MEETING #6 SUMMARY NOTES

PLU Airport Master Plan Master Plan Advisory Committee (MPAC) Meeting #6

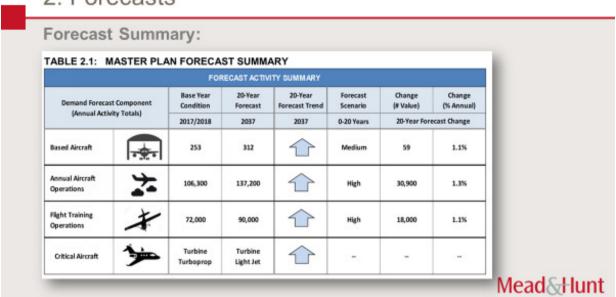
Meeting #6 MPAC decision items:

Final	Forecast	Chapter	Accepta	ance
--	-------	----------	---------	---------	------

- ☐ Runway Extension Scenario Master Plan Recommendation
- ☐ 'Westside' Terminal Planning Master Plan Recommendation
- ☐ 'Eastside' Terminal Planning Master Plan Recommendation
